PHOTOGRAPHS

**PHOTOGRAPH #10**

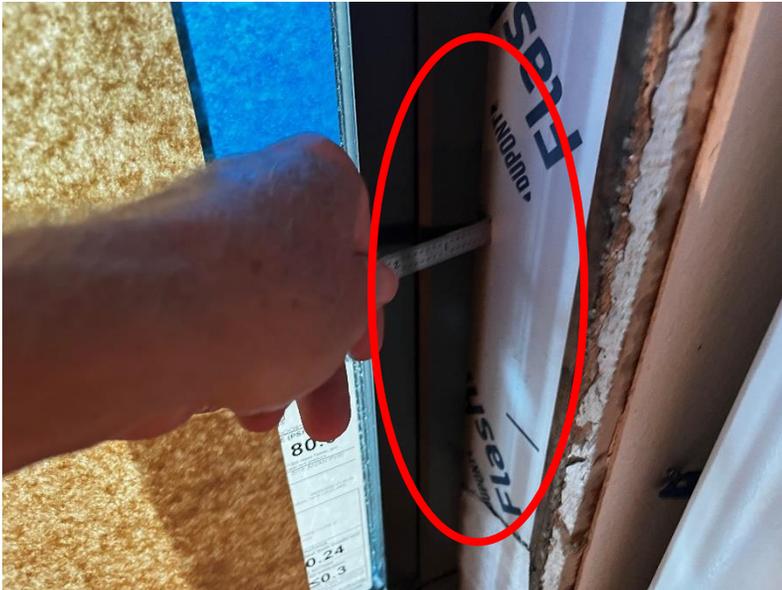
New BASF sealants applied at window band stucco to stucco transition and window covered for protection.

**PHOTOGRAPH #15**

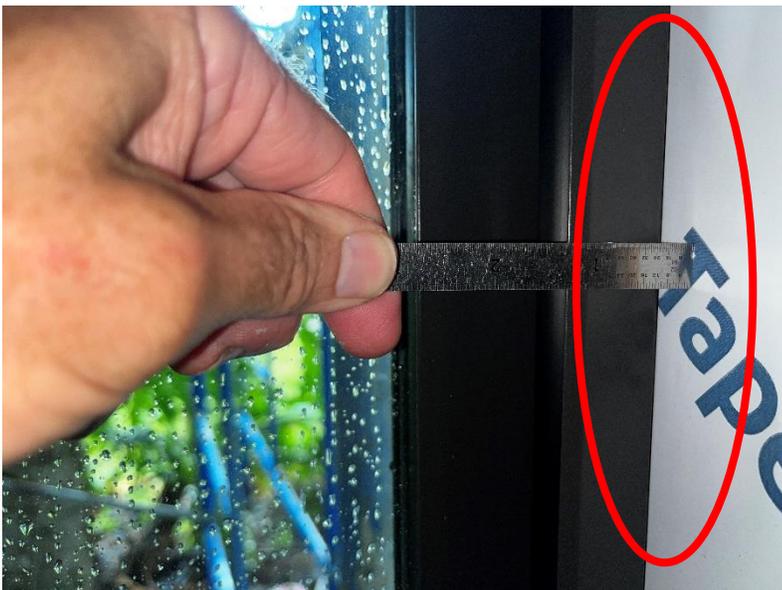
Window fin fasteners installed to wood framing at 5" O.C. as per drawings and manufacturer's NOA

**PHOTOGRAPH #21**

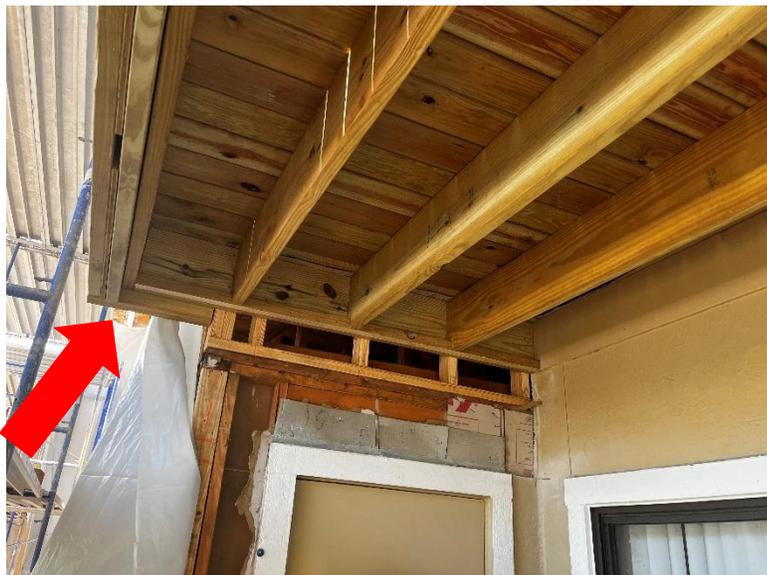
Contractor has not followed Balcony Edge / Rail Beam Detail S-7.4 positioning new built-up beam to low
